May 11, 2018

BOARD OF COUNTY COMMISSIONERS
ORANGE COUNTY, FLORIDA

ADDENDUM NO. 4 / IFB NO. Y18-758-TA

SOUTH SERVICE AREA/EAST SERVICE AREA (SSA/ESA) 36-INCH POTABLE
WATER MAIN, 24-INCH RECLAIMED WATER MAIN AND J. LAWSON BLVD
POTABLE WATER RE-PUMP FACILITY

SCALE:
DRAWING NO.:
D-100
SHEET: 183 OF 292

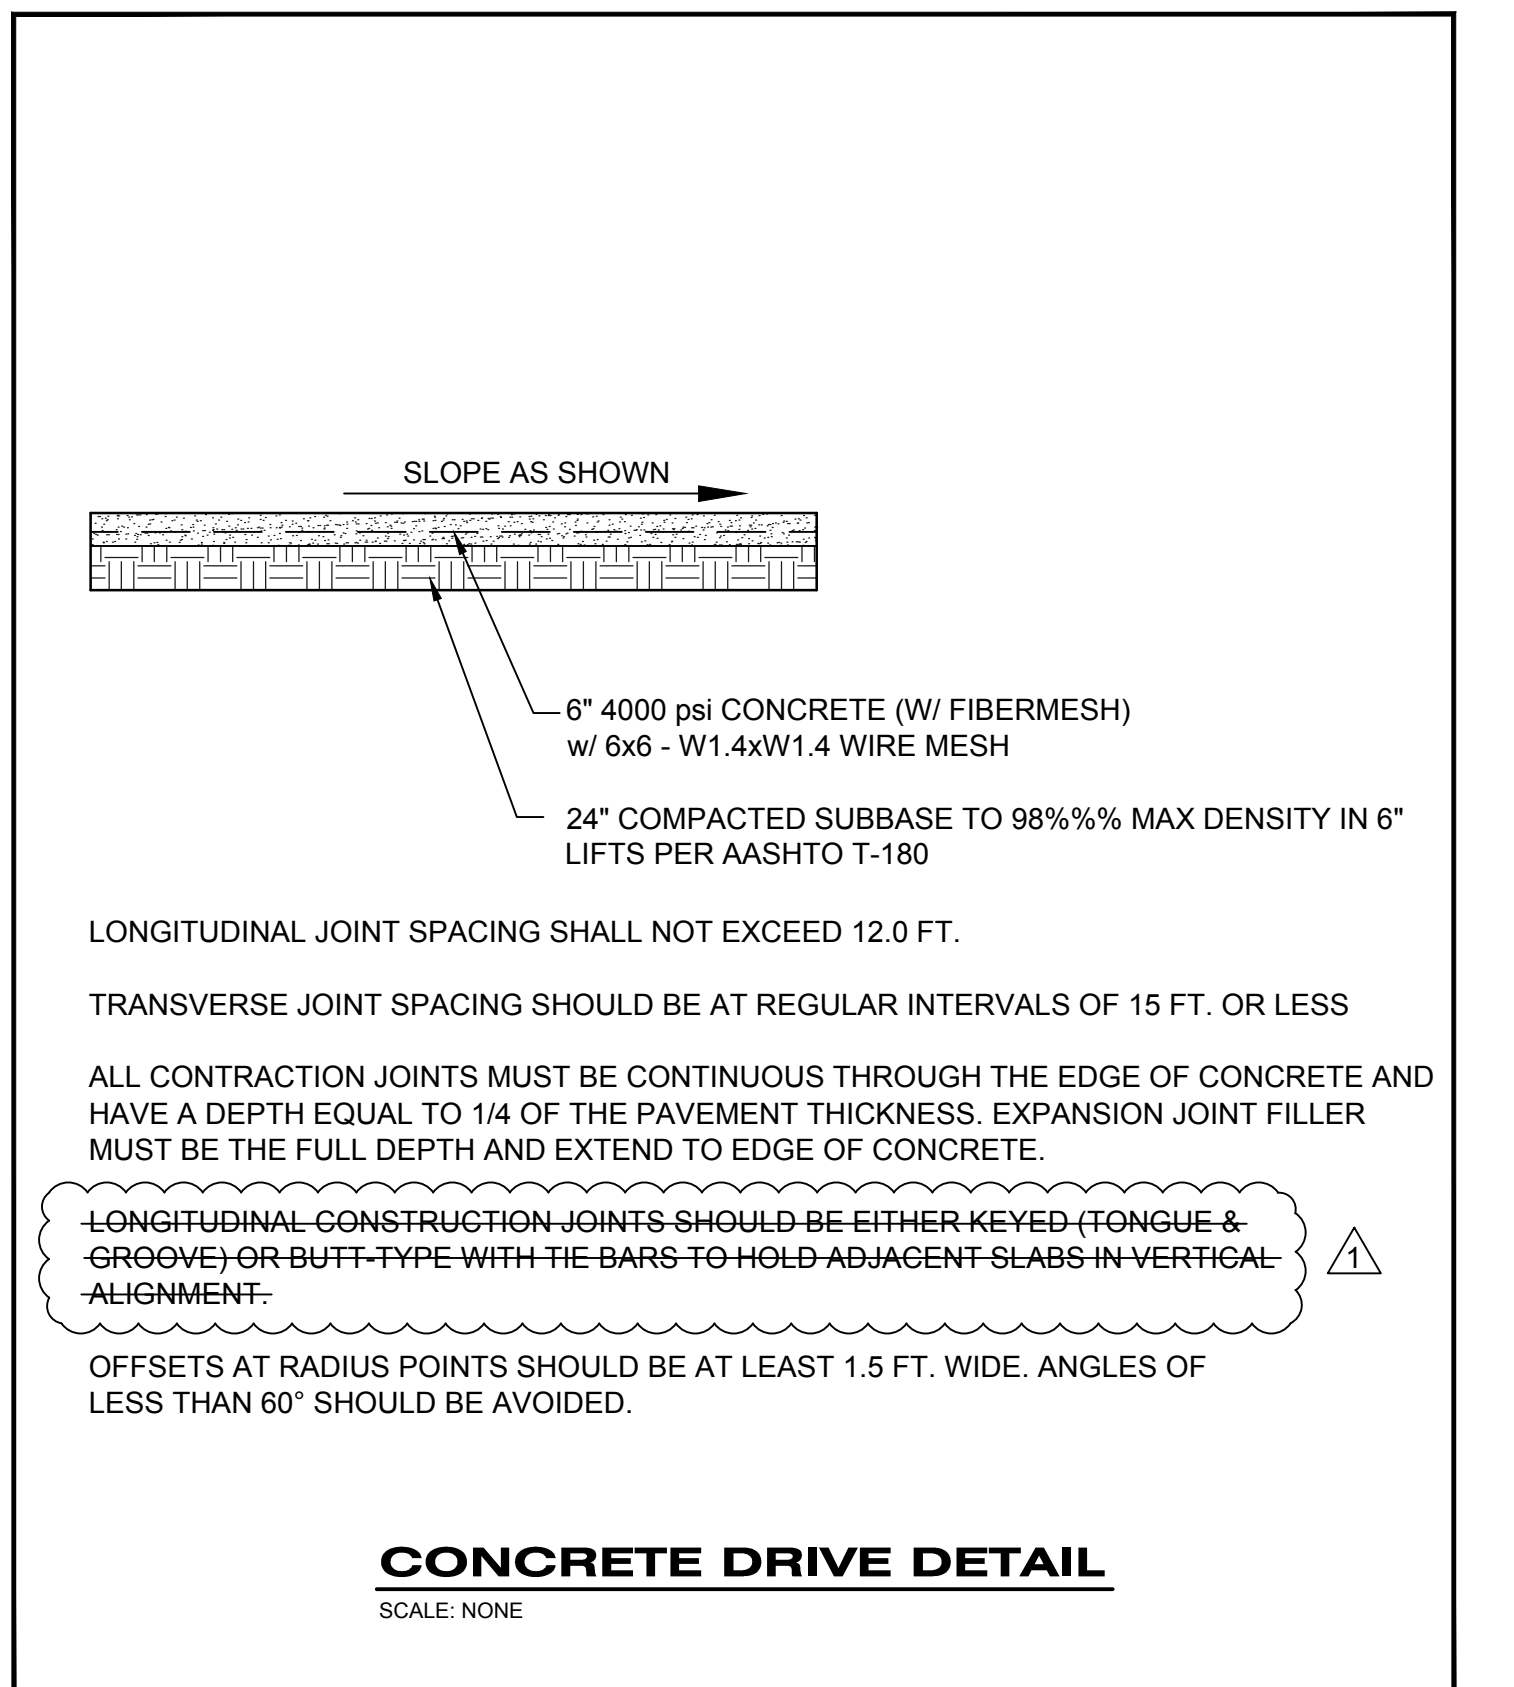
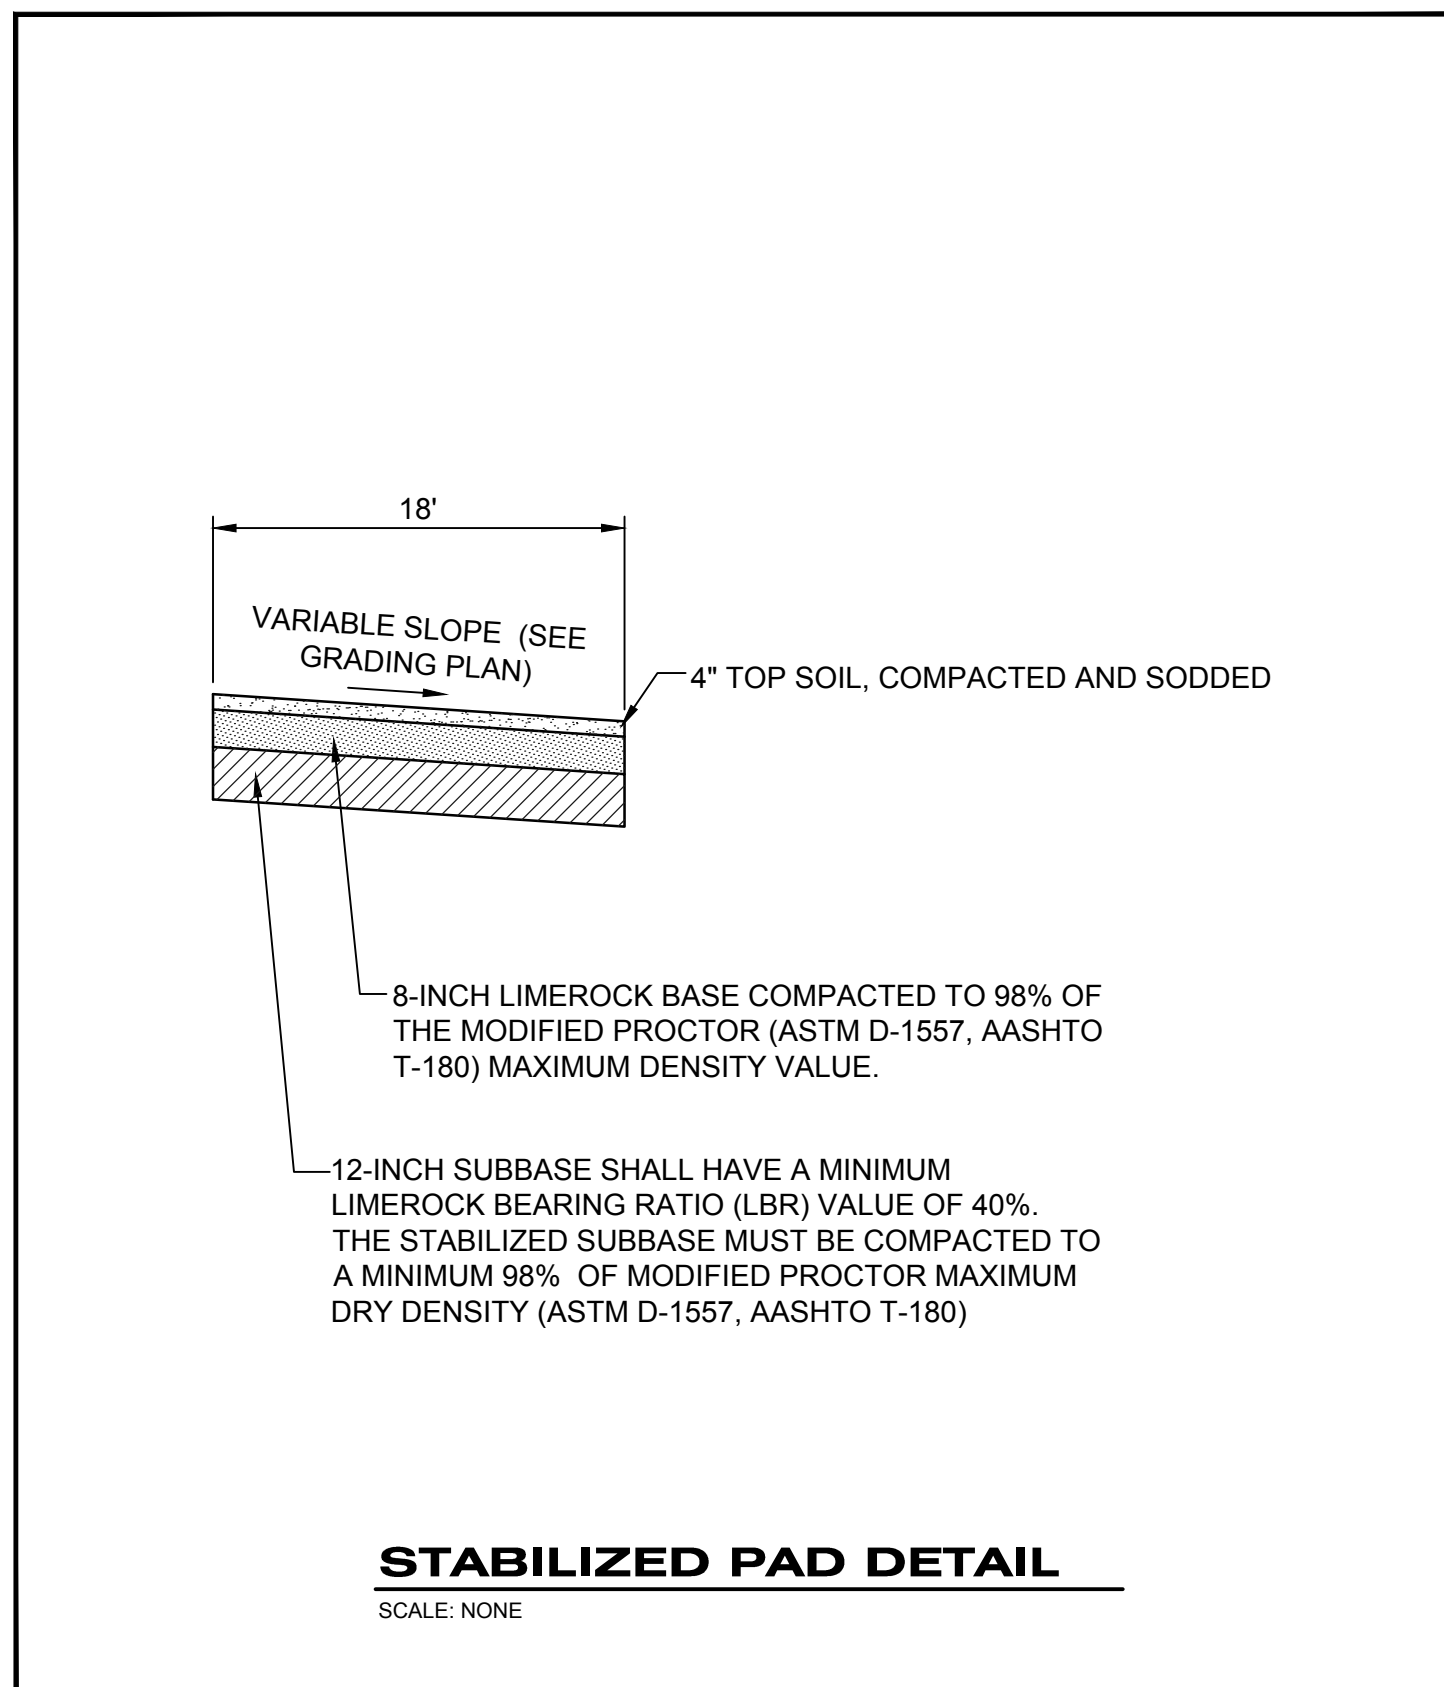
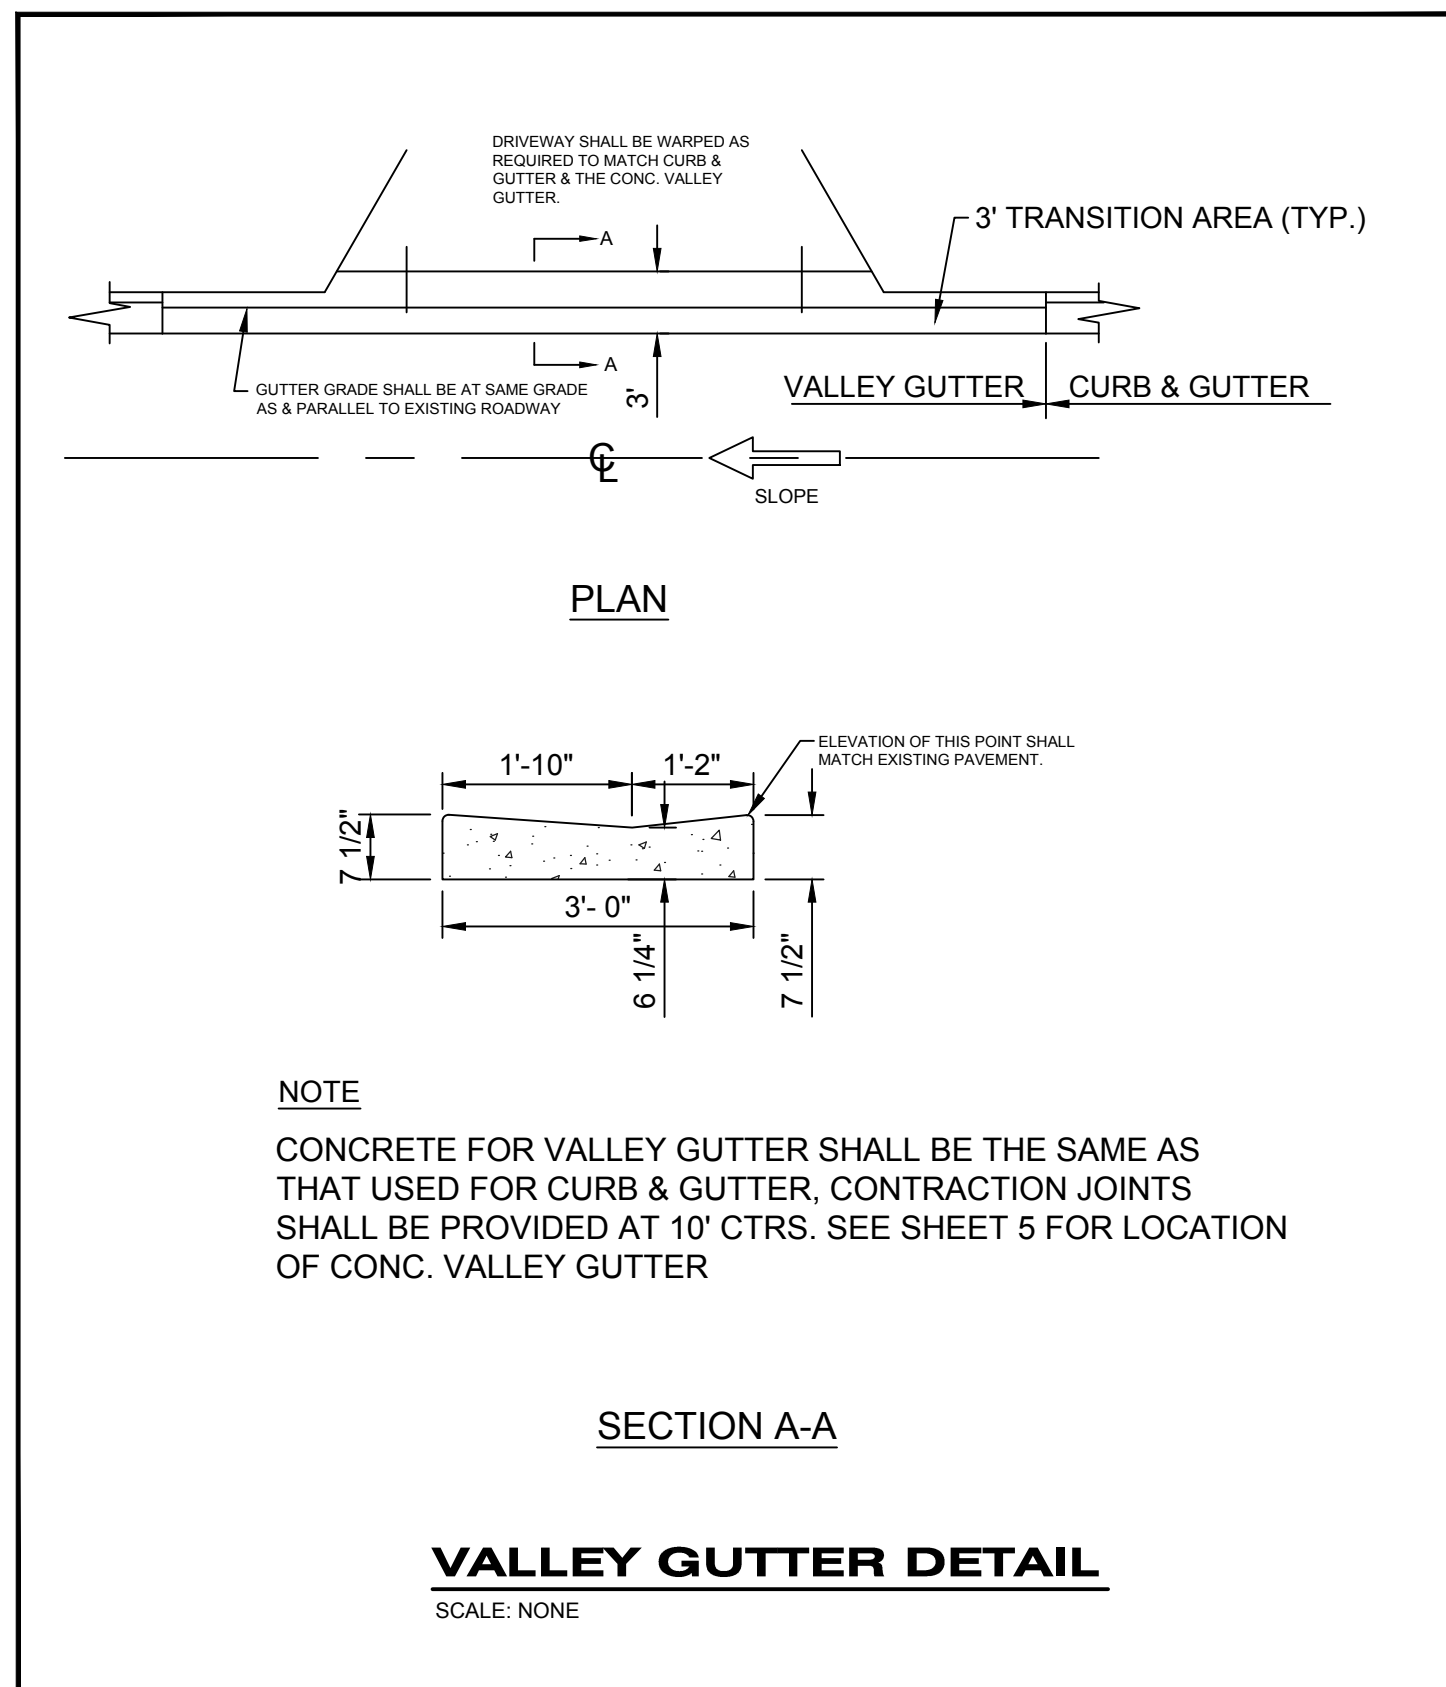
47. Q Regarding the Concrete Drive Detail on Sheet D-100, the 4th note mentions using tie bars to hold adjacent slabs in vertical alignment. Please clarify the tie bar spacing required.

DRAWING D-100 – CONCRET DRIVEWAY DETAIL

A: The Tie Bars or the keyed joints will not be required for this project.

Amend: Delete the fourth note regarding longitudinal construction joints
